Subject: Broken Hill Battery Energy Storage (BESS), Modification 1 (SSD-11437498-MOD-1)

ATTACHMENT A – BCD comments on Broken Hill Battery Energy Storage – Modification 1 (BESS) (SSD-11437498-Mod-1)

Attachment A – BCD comments on Broken Hill Battery Energy Storage – Modification 1 (BESS) (SSD-11437498-Mod-1)

Attachment B Disturbance footprint discrepancy between BDAR and Broken Hill BESS Modification Report

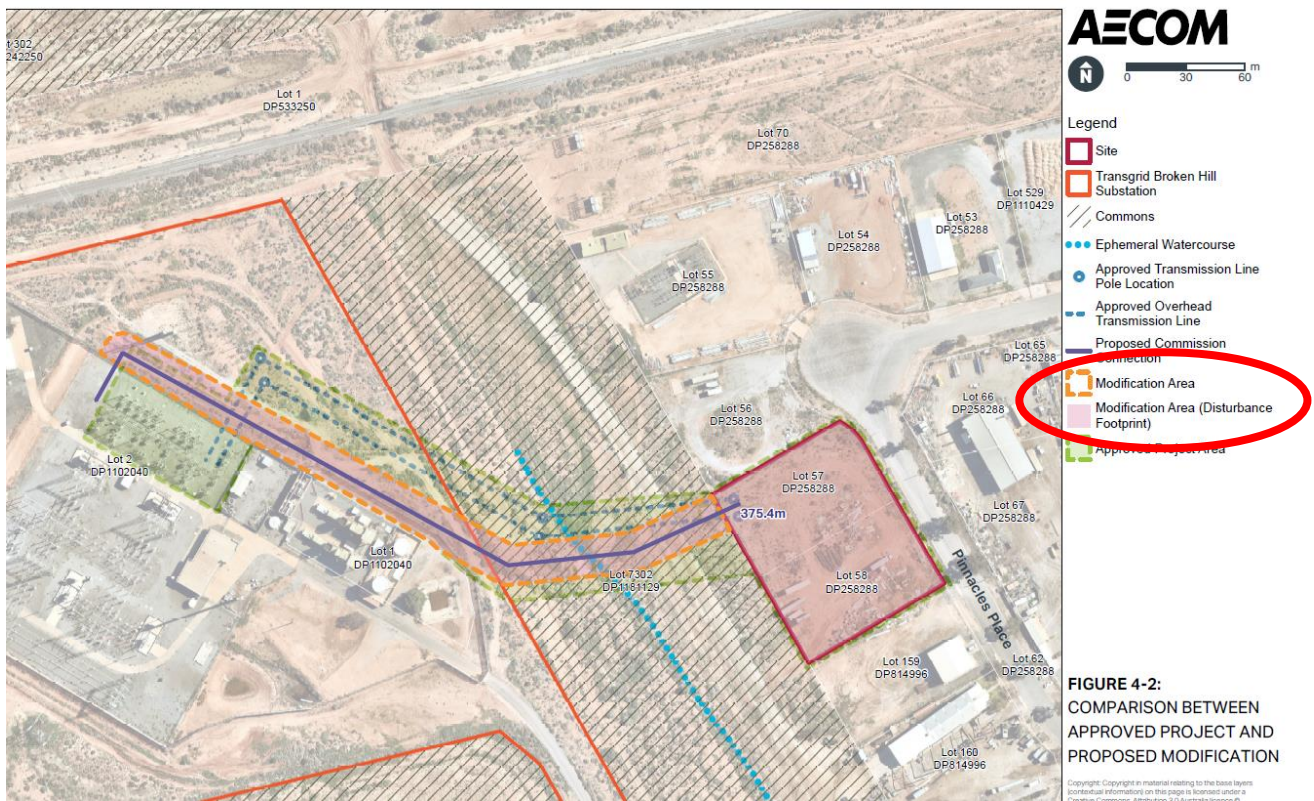
1.	<i>Assessment area is incomplete and inconsistent with the Modification Report</i>	<p>The BDAR has assessed a smaller development footprint than the Modification Report</p> <p>Appendix B shows the discrepancy between the development footprints used for the Modification Report and BDAR.</p> <p>Assessment of the battery site (Lots 57 and 58) is not included in the BDAR. The BDAR does not mention that any previous assessment will be used to supplement the Modification BDAR, but the offset summary includes a credit requirement for an additional area (0.31 ha of PCT 155) matching the hectares of native vegetation on the battery site.</p> <p>BCD understands that the Modification Approval, if granted, would replace the current project approval, so the assessed disturbance footprint should have included the battery site.</p> <p>Recommended action:</p> <p>1.1. Revise the BDAR to include assessment of the whole disturbance area as described in the Modification Report.</p>

Modification disturbance footprint is shaded pink (Modification Report Fig 4-2)

BDAR assessed area is outlined in yellow (BDAR Fig 1)
